GJS Plot F, Manchester

Tower F2 - Podium Design | 26.04.2024

F2-SHP-A180-RP-XX-B5D803 | P04

Background to the report

Louvred panels with decorative aluminium screening

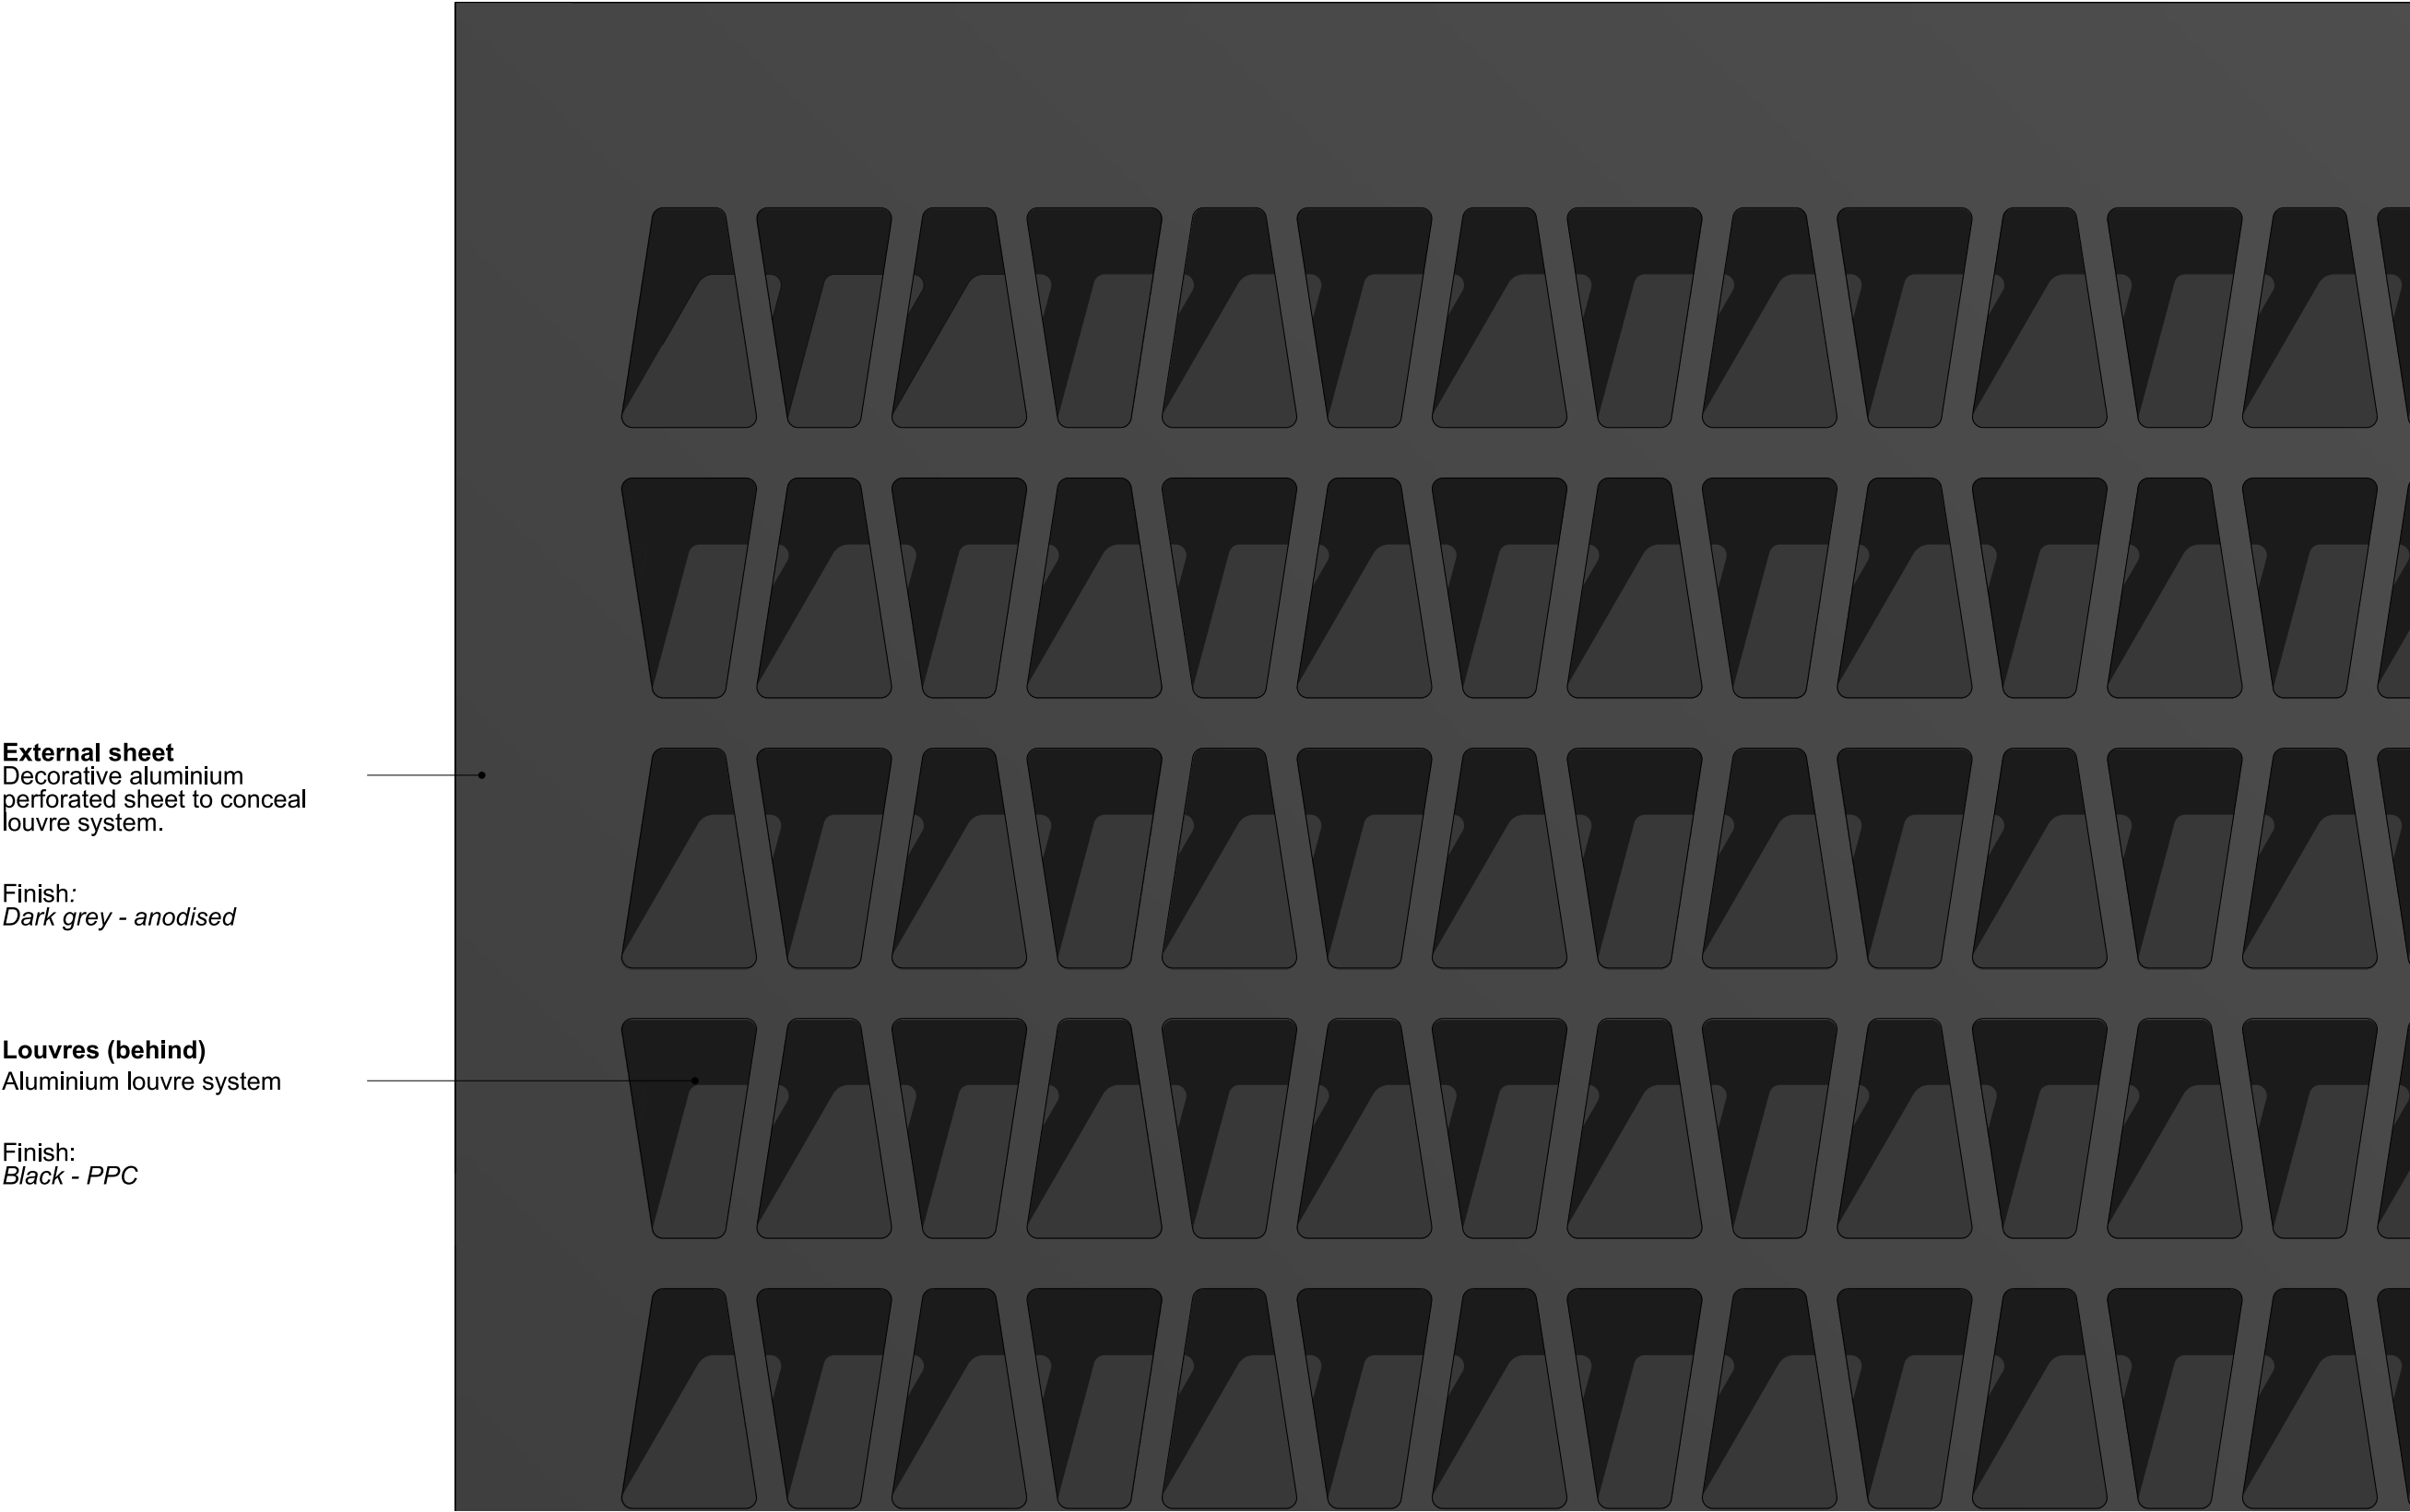
As requested by MCC, the design team have developed a proposal to screen the full height louvres and have applied the same rationale to the high level louvre band at ground floor.

A decorative pattern has been developed that acknowledges the corner geometry of the towers above whilst maintaining a relationship with the horizontal brick coursing adjacent.

Due to the provision of the screening and resultant loss in free area, the high level louvre band has had to increase in depth.

The decorative screens are proposed in a dark anodised finish. Behind the screens, where active ventilation connections are required dark louvres finished in black PPC are proposed. Where active ventilation connections are not required a solid aluminium blanking panel will be used finished in black PPC.

Updated Proposal - Decorative Screens

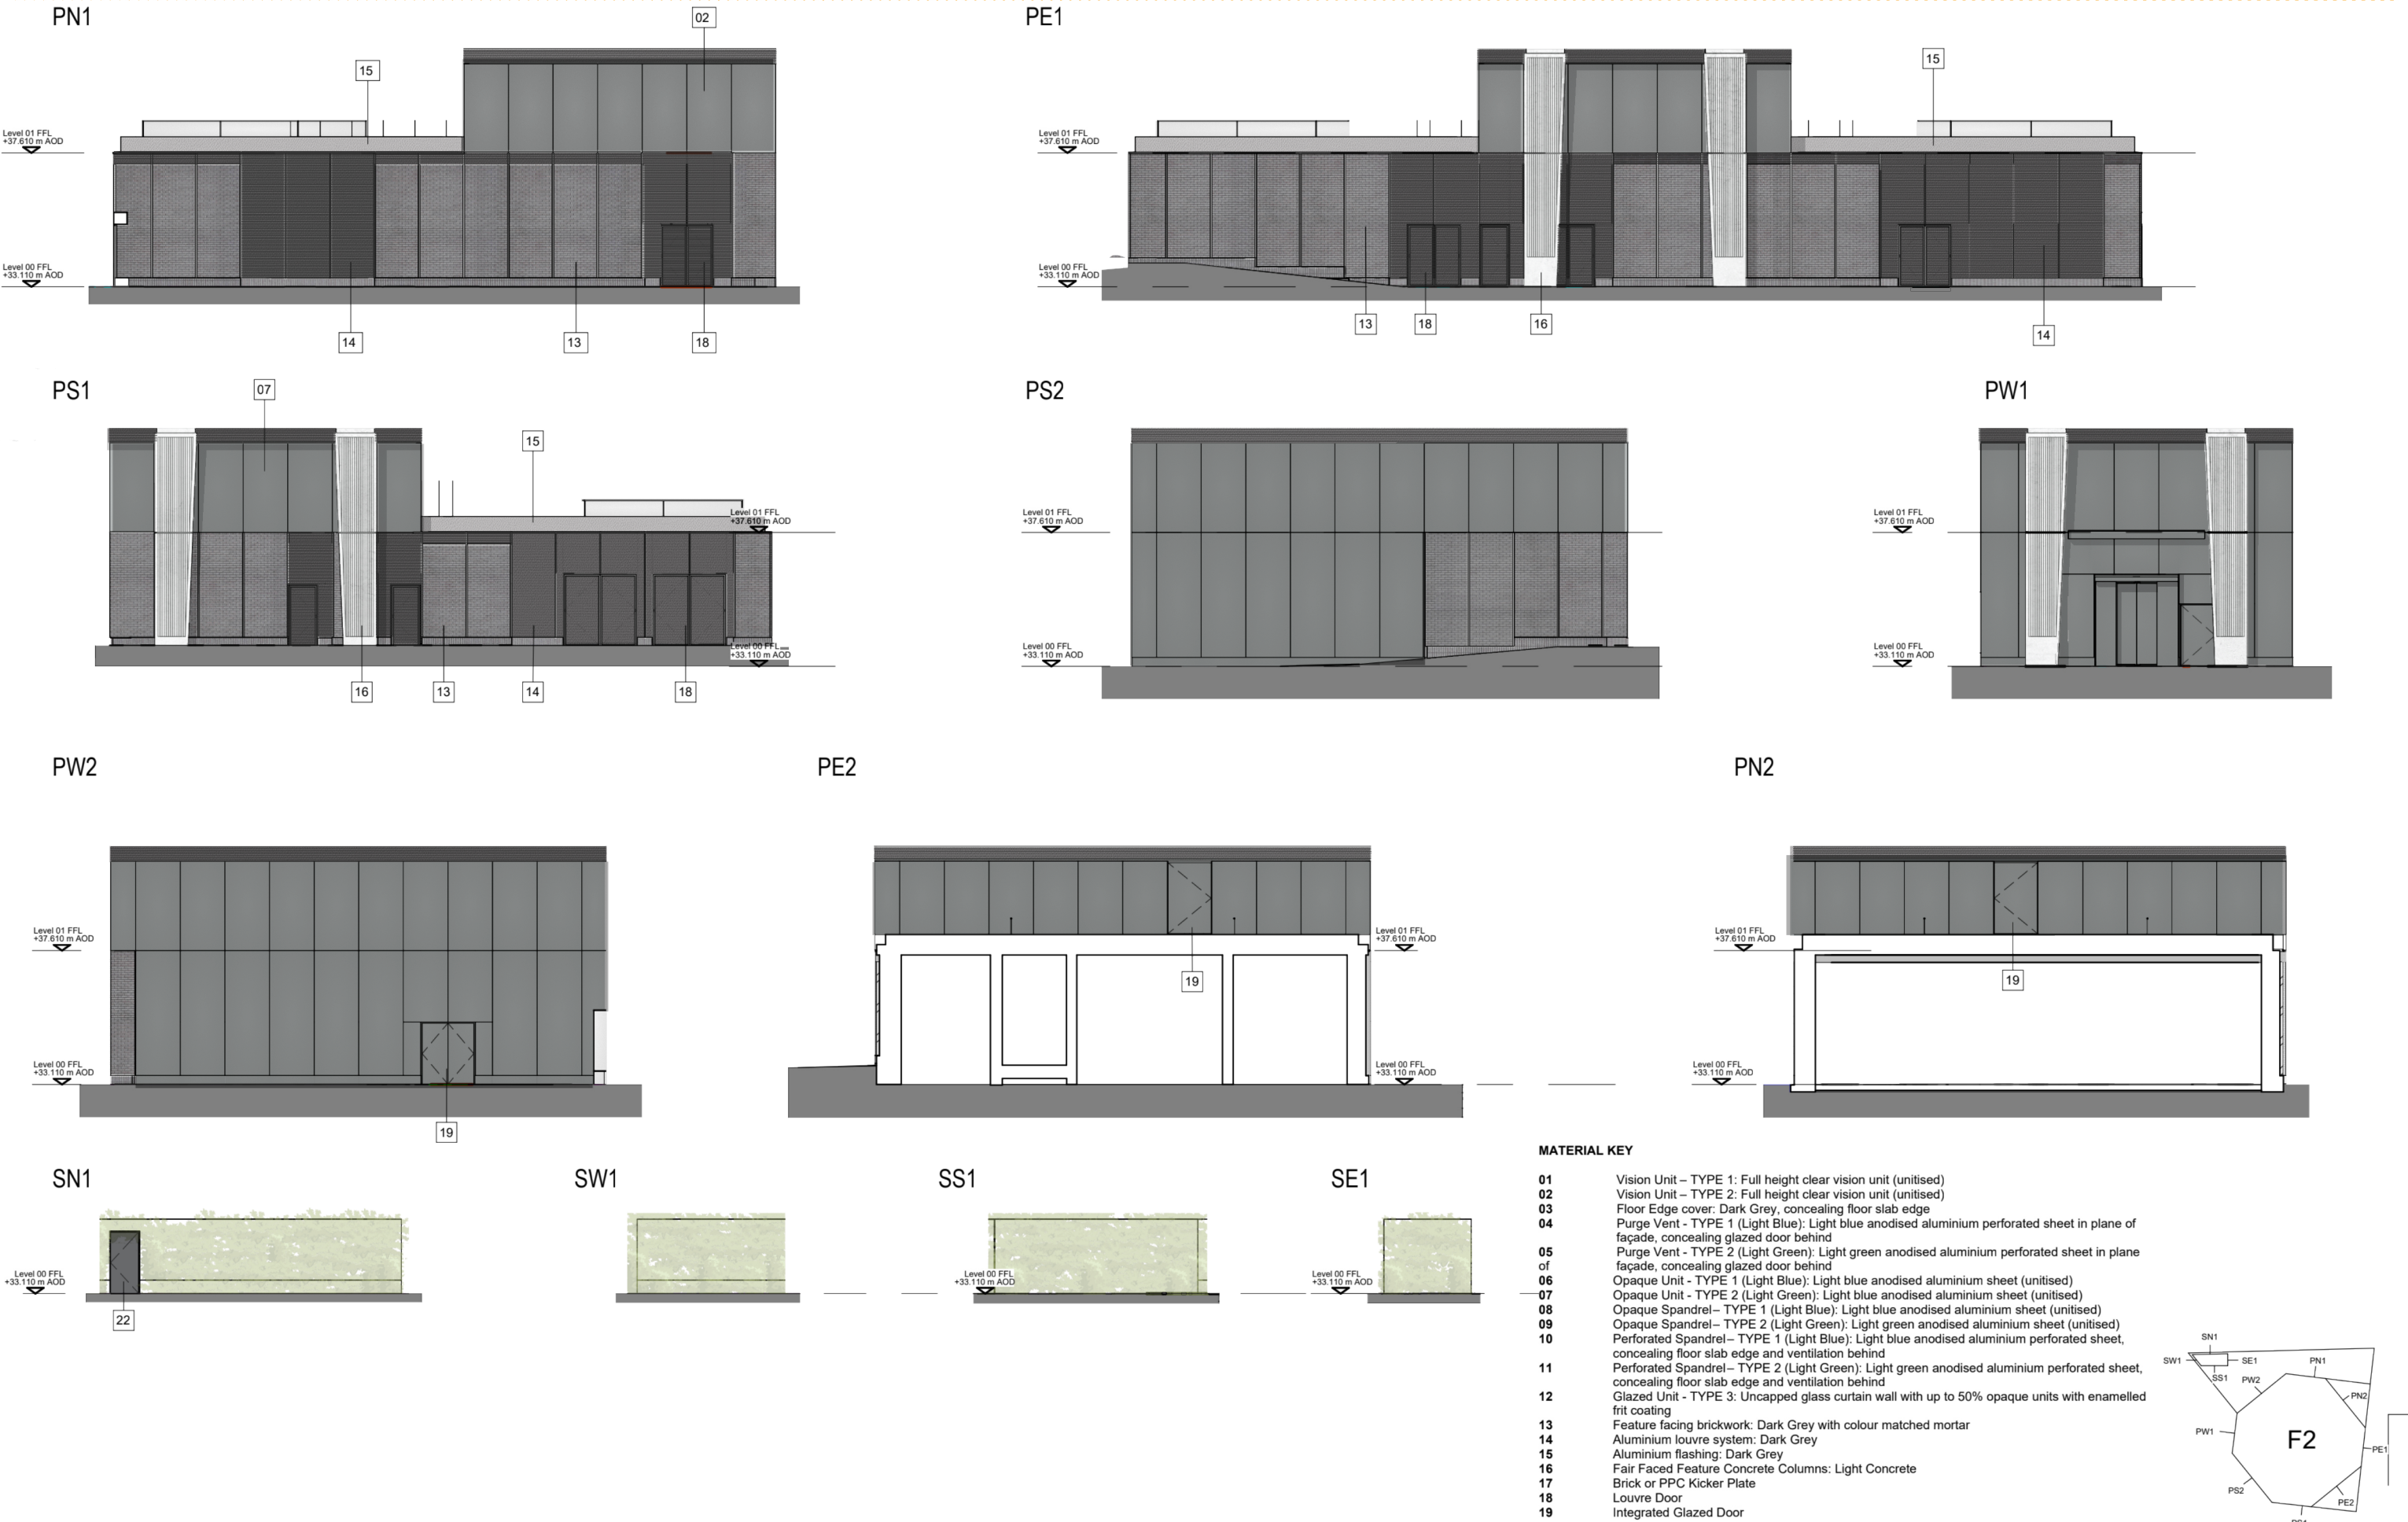
Further to the above application, I note that there are large areas of louvres proposed for the ground floor elevations where there are plant and waste storage rooms. As these areas front onto pedestrian thoroughfares and will be highly visible, please would you look at using anodised aluminium decorative screening (eg to match the purge vents on the floors above) instead of, or to screen, the large areas of louvres.
